Sudden Valley Community Association Architectural Control Committee

Agenda

Date 08/20/2026

Type of meeting: Request and Plan Review

View looking east of Tree 1 showing large crown hanging over driveway/vehicles & roof. 40 Rocky Ridge Dr. 8/8/26

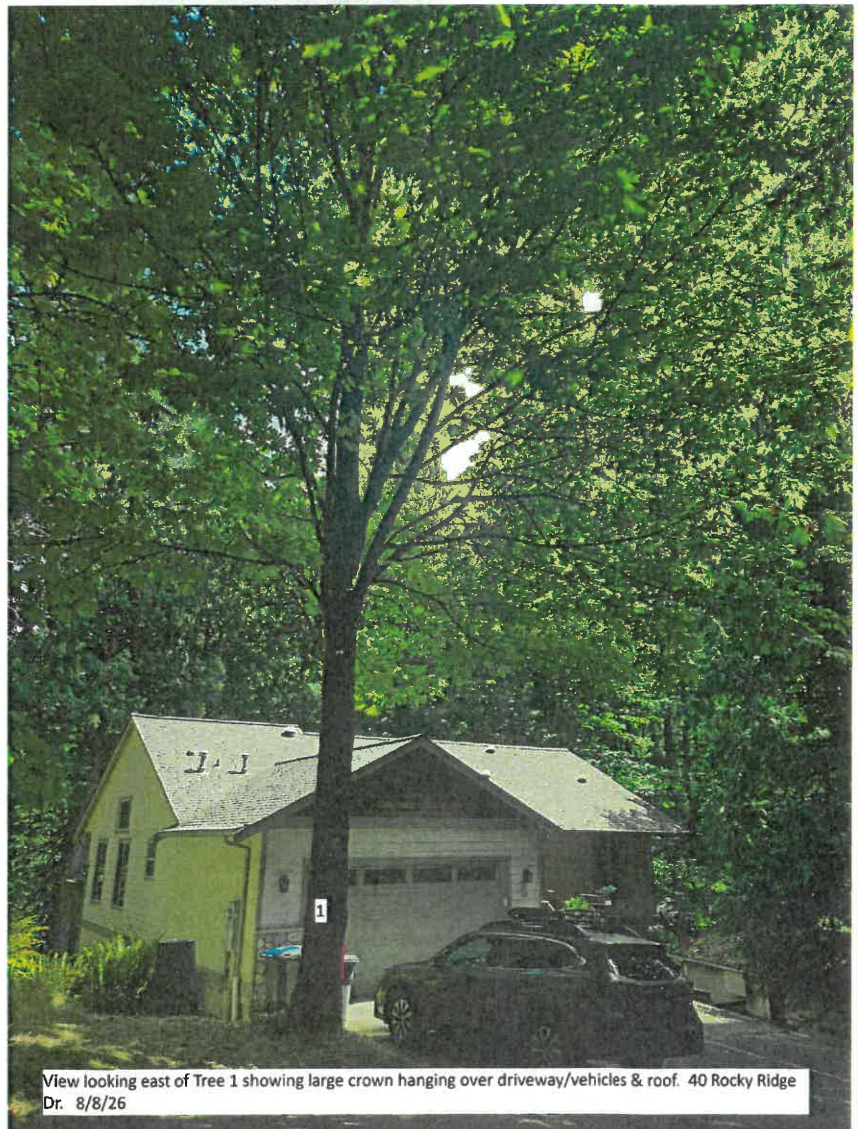
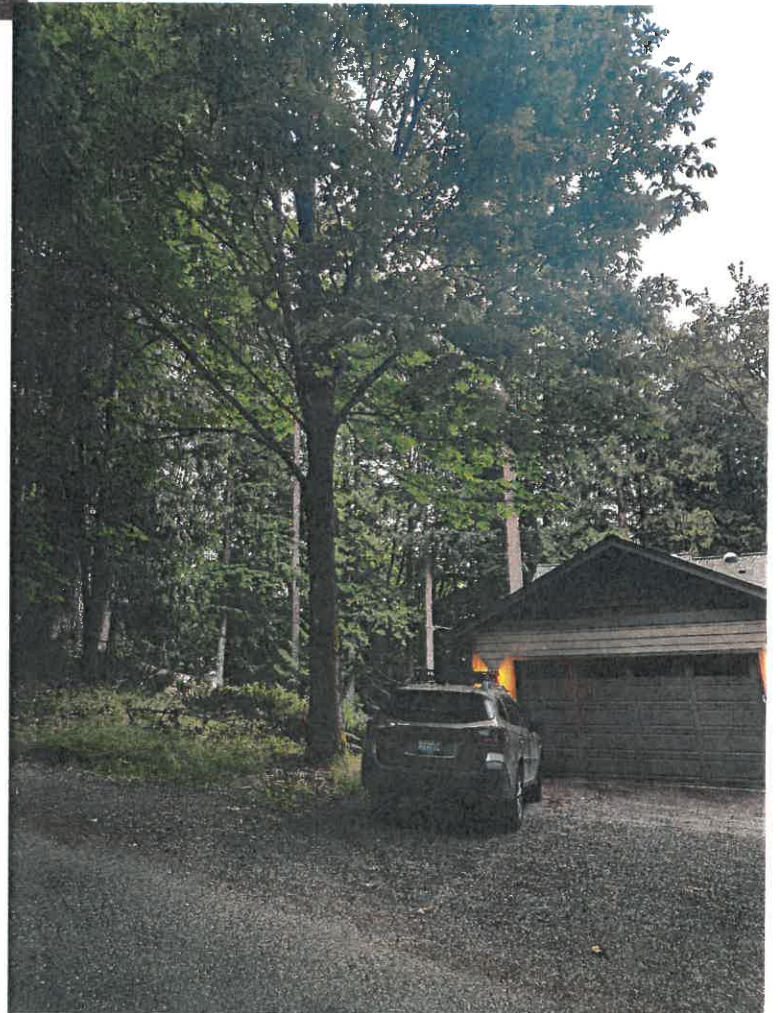
Item – 17	40 Rocky Ridge Dr, G3, Tree (Remove 1)		Video 00:00:00 – 00:00:00
Comments:	Please consult with an Arborist to discuss ways of bracing limbs, removing limbs, or a combination of both		
Discussion:	To preserve the tree.		
Action:	Denied	Motion: Terry	Unanimous

RETAINING WALL RAILING

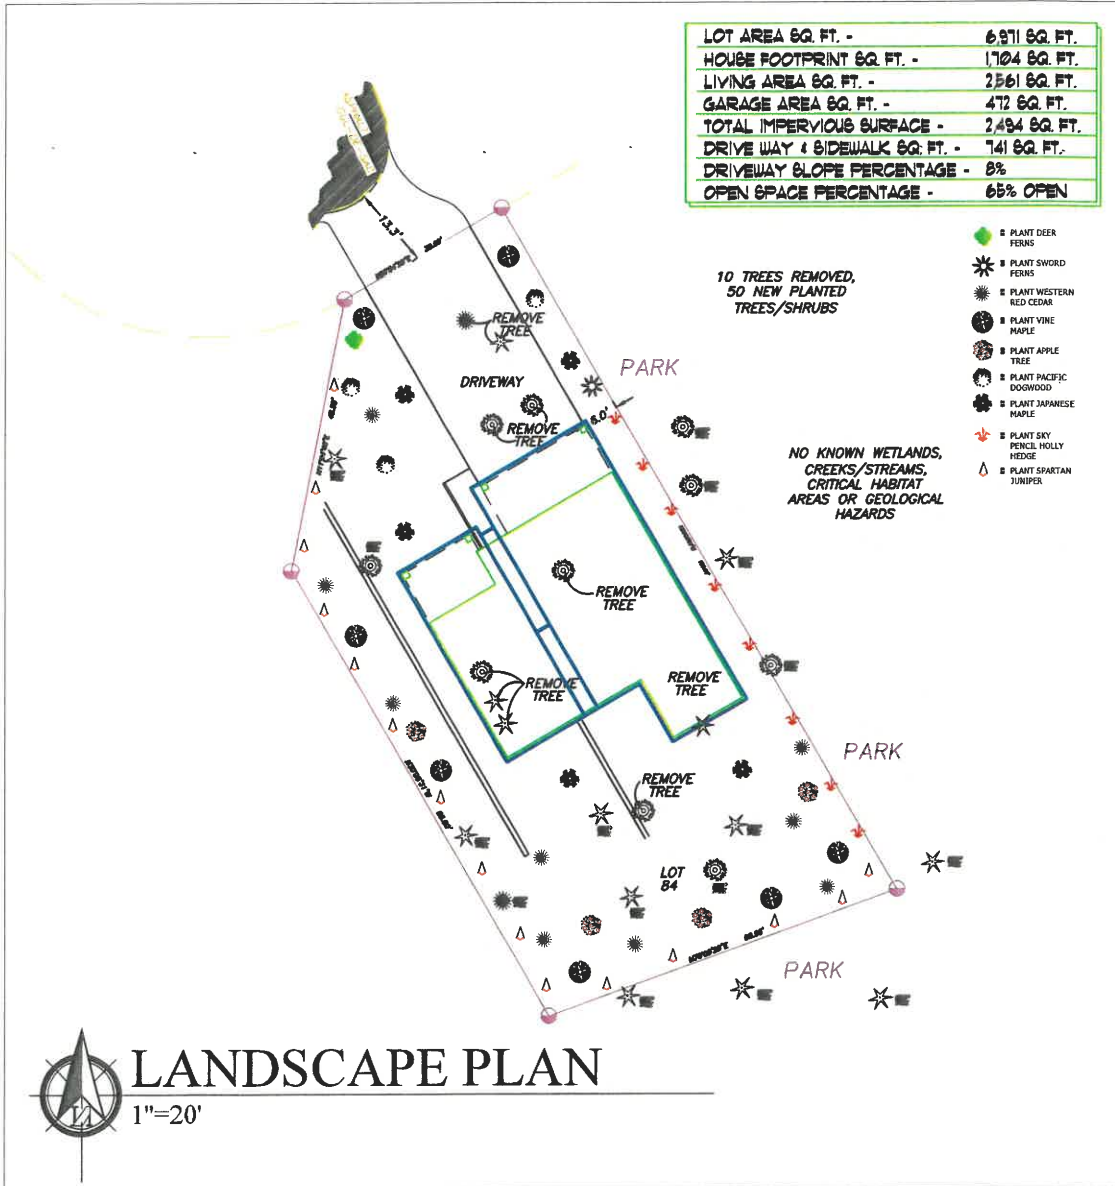
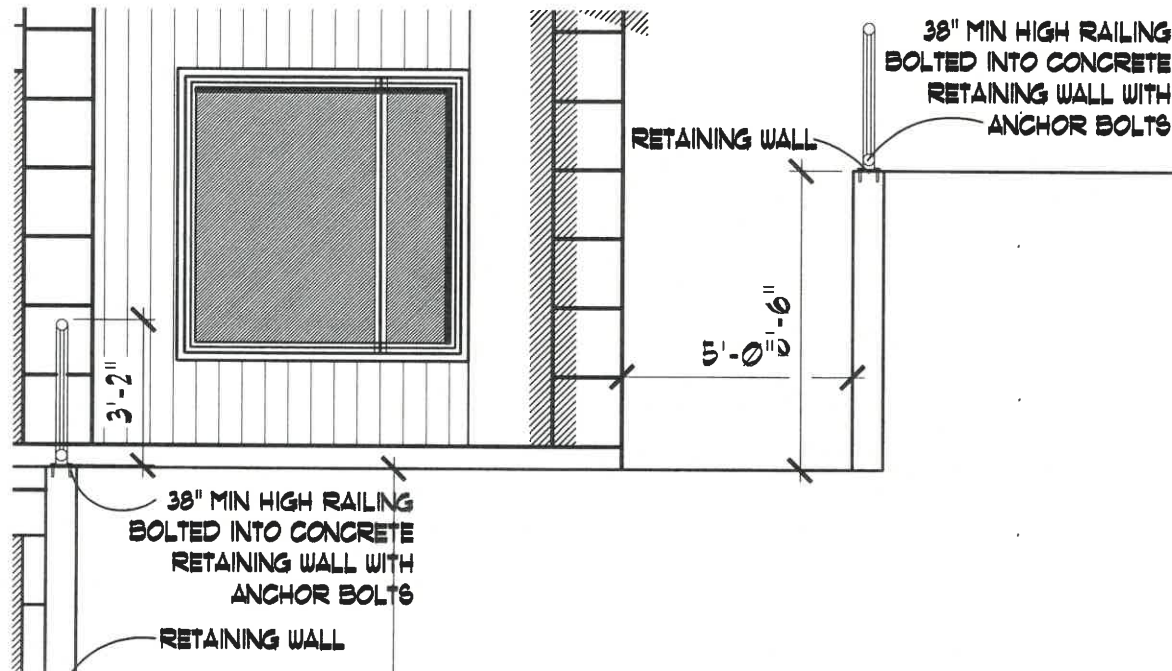
Item – 19	26 Shetland Ct, G5, New Construction <i>Resubmission</i>		Video 00:49:06 – 01:32:30
Comments:	Install a guardrail at the top and along the length of the retaining wall following the Whatcom County Building Code. Provide a Landscape Plan showing the existing trees in relation to an outline of the house.		
Discussion:	Show which trees are being removed and where the new trees are being planted. Use a ration of five new trees to be planted for each one tree being removed.		
Action:	Denied	Motion: Daniel	Unanimous
